CITY PLANNING COMMISSION

- APPLICATION:
1. Negative Declaration
 2. Point West PUD Schematic Plan Amendment from Light Industrial to Office Designation;
 3. Rezoning from Light Industrial-Review Parkway Corridor (M-1(S)-R PC to Office Building-Review Parkway Corridor (OB-R PC);
 4. Special Permit to develop a 24,650± square foot office building on 1.4± vacant acres in the Office Building-Review Parkway Corridor (OB-R PC) zone and the Point West PUD;
 5. Special Permit to allow a detached monument sign in addition to a 64 square foot attached sign;
 6. Plan Review for a 24,650± square foot office building.

APPLC. NO. P84-151

STAFF EVALUATION: Staff has the following comments and concerns:

SITE PLAN

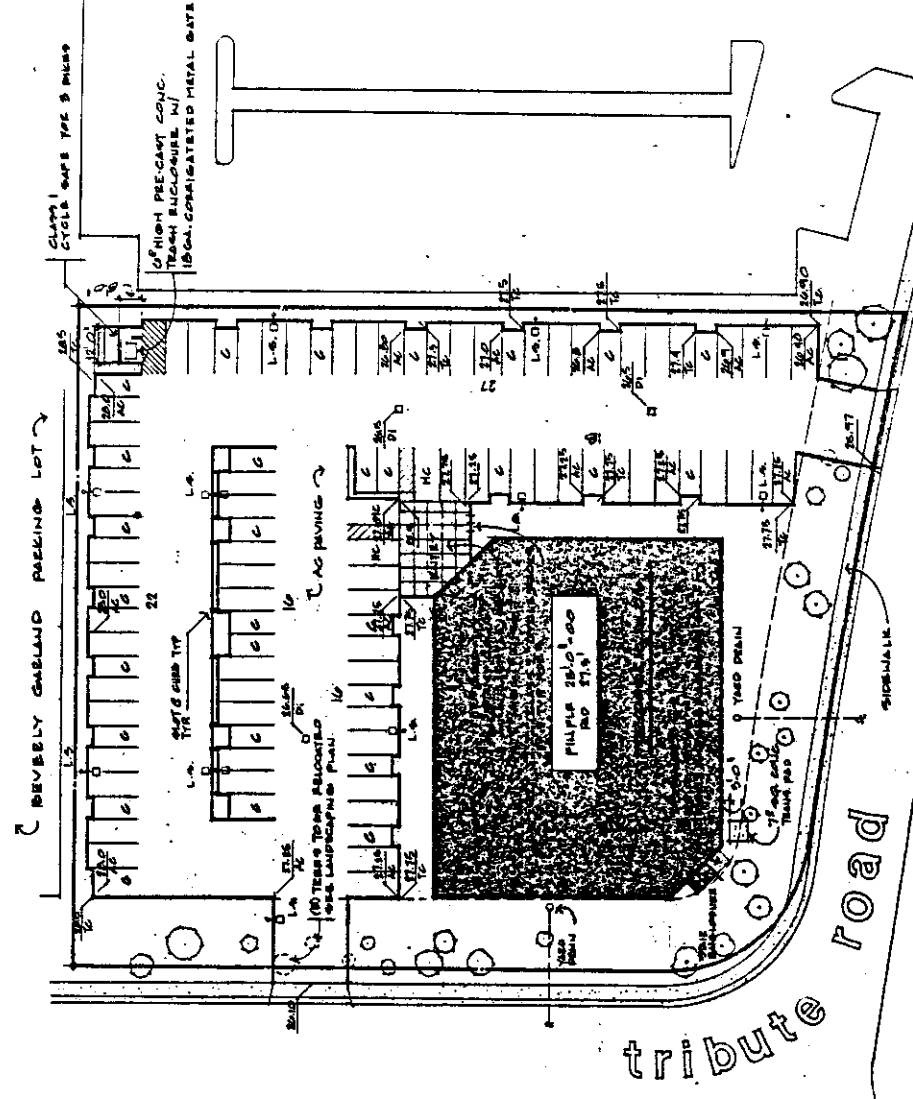
- a. Traffic requires that driveways be at right angles to the street and that a driveway permit is required. (The driveway angle has been changed to accommodate this preliminary review comment);

- 2) The trash enclosure as located in the northeast corner of the site should be highly screened from view by the adjacent property owners. It was mutually agreed that the applicant would screen this area;

- 3) The bicycle lockers located adjacent to the trash enclosure in the northeast corner of the property are not aesthetically pleasing. It is suggested that provisions for bicycle storage be shifted to the interior of the building or that this requirement be lifted;

- 4) The Committee also recommends that additional landscaping be added at the southwest corner of the site to more fully balance the landscaping design as provided for the balance of the property. A more detailed plan of the entire site should be submitted to the Committee for their review prior to occupancy certificate;

- 5) At the east property line it is suggested that the landscaping plan be modified to be compatible with the mature trees on the adjacent properties. With the assistance of the mature trees, the landscape budget could be shifted to more fully landscape the remainder of the site.

7. A SMUD transformer is currently located near the corner and in the 25-foot landscaped setback. This should be sufficiently landscaped so as to screen the equipment and yet leave the adequate space for utility access.

8. All lighting should be specifically directed downward and designed to reduce light directed to or reflected at the American River Parkway.
9. One bicycle parking space is required for every 15 vehicle spaces. Fifty percent of these must be Class I facilities. Three Class I facilities are shown on the site plan. Fifty percent calculates to four spaces; therefore, a revised site plan showing at least four spaces should be submitted for review and approval. The remaining Class II or III is indicated on the site plan.

The applicant has indicated that the Class I facility requirement would consist of a metal bike locker for three bikes. Staff suggests that an enclosure be designed with a lockable gate around the bike lockers similar to the trash enclosure in order to visually screen the bike locker. Additional planting should also be provided around these bike and trash enclosures.

- a. The applicant shall screen the roof-top equipment with material similar to the exterior building. Design and elevations shall be reviewed and approved by the Planning Director;
- b. The applicant shall design an enclosure with a lockable gate for the Class I bike lockers. This design shall be integrated with the trash enclosure and shall be reviewed and approved by the Planning Director;
- c. The proposed parking lot lighting shall be directed downward and designed to reduce light directed or reflected toward the American River Parkway;
- d. The landscape, irrigation and shading plan shall be revised to include the following:
 - 1) the SMUD transformer shall be screened with shrubs;
 - 2) additional planting (shrubs and trees) shall be provided around the bike and trash enclosures.

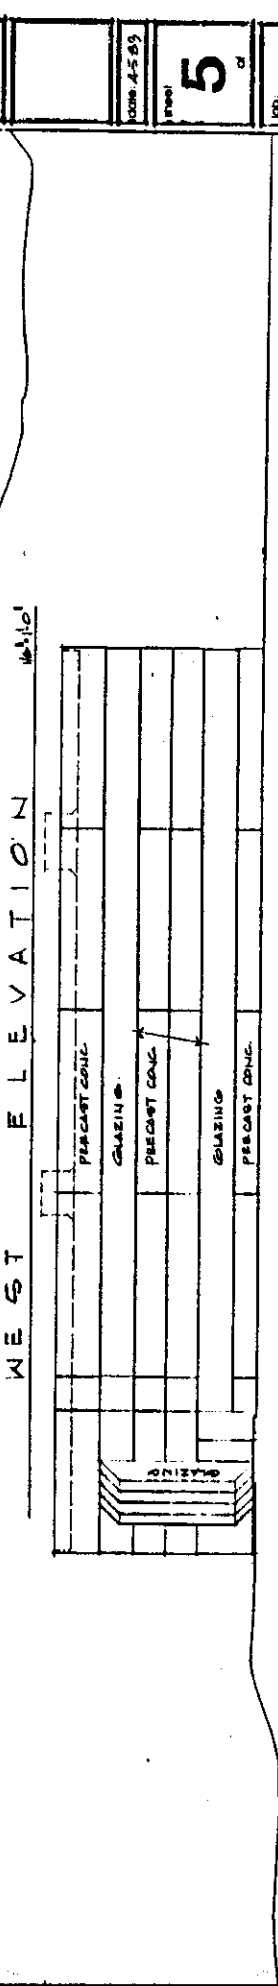
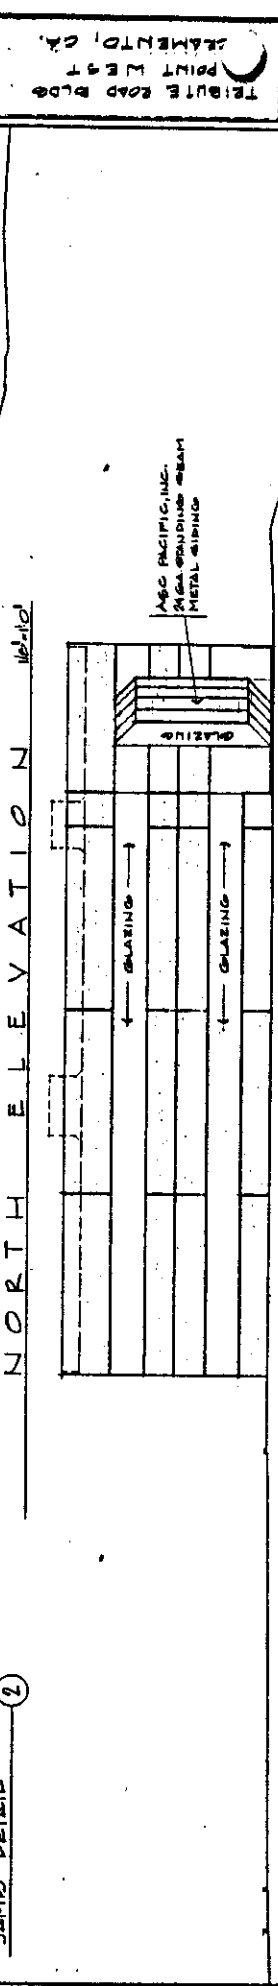
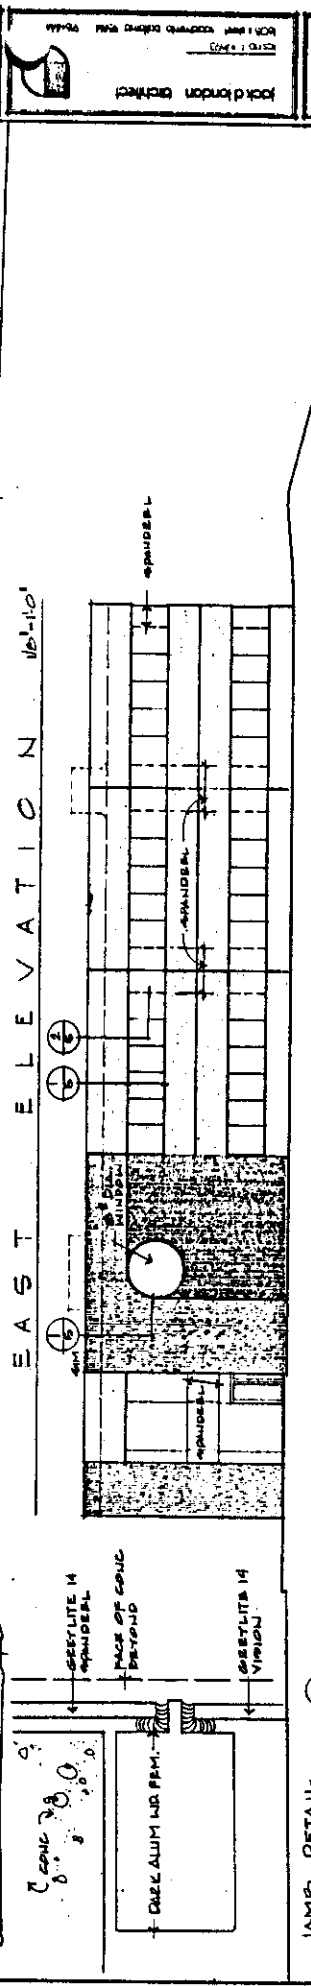
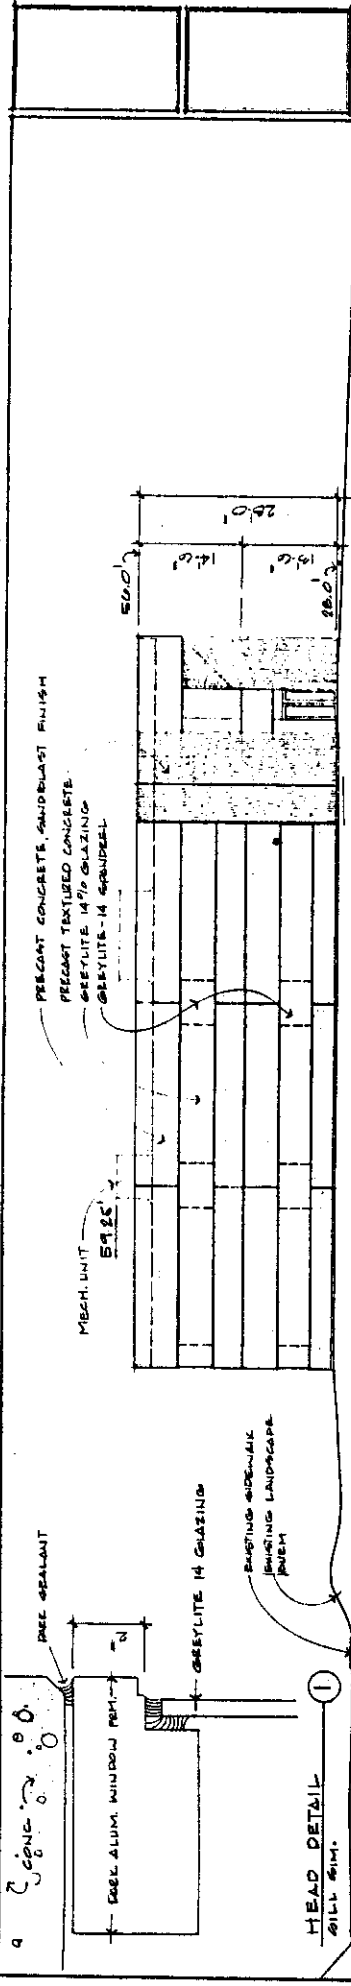
10. The submitted elevations indicated one attached sign (2' x 32') on the south elevation and one monument sign (3'6" x 5'). The Sign Ordinance and the Point West Sign Guidelines allows only one sign. Staff discussed this sign issue with the applicant who indicated that the attached sign will be eliminated from this proposal. However, the applicant proposes to utilize the proposed monument sign and provide tenant identification. The Sign Ordinance and Point West Sign Guidelines allow one monument sign not to exceed six feet in height. The applicant, however, should be aware that the Sign Ordinance requires that detached signs, when located in the OB zone, cannot be located in the building setback areas. The Point West Sign Guidelines, however, require a 10-foot setback for detached signs. The applicant therefore will have to apply for a variance from the Commission prior to issuance of the sign permit.

11. The proposed two-story structure consists of pre-cast concrete that has a sand-blasted finish and a textured finish. The windows are a greyite material. The west and south elevations contain a glass projection which is basically an enclosure for the stairs. The Point West Architectural Review Committee and Planning staff have no objection to the design of the building. The proposal basically conforms to the building standards of the Point West Development Guidelines. In addition, the structure is compatible to the adjacent building (Exploration Logging) which also consists of pre-cast concrete material.
